Hi-Fi Products
Service Bulletin

Model: CDP-C400/C401/C500

No. 88

Subject: Part Number For BU Bracket and
Transit Lock

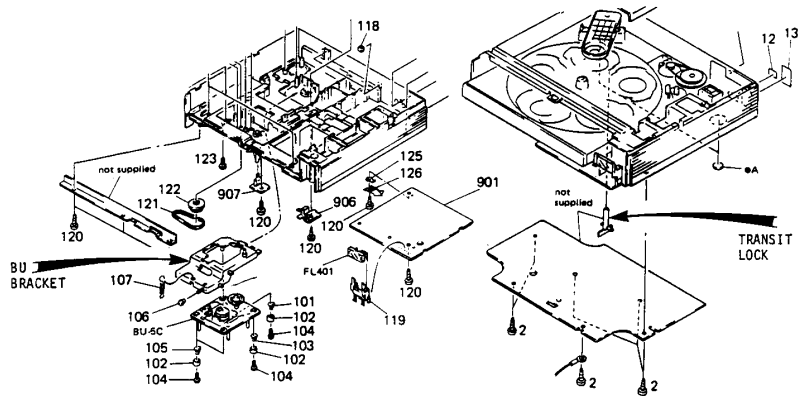
The part number for the BU bracket and transit lock are not listed in the service manual.

Solution: Please add the following part number to your service manual:

Description	Part Number
BU Bracket	4-930-504-03
Transit Lock	4-930-510-01
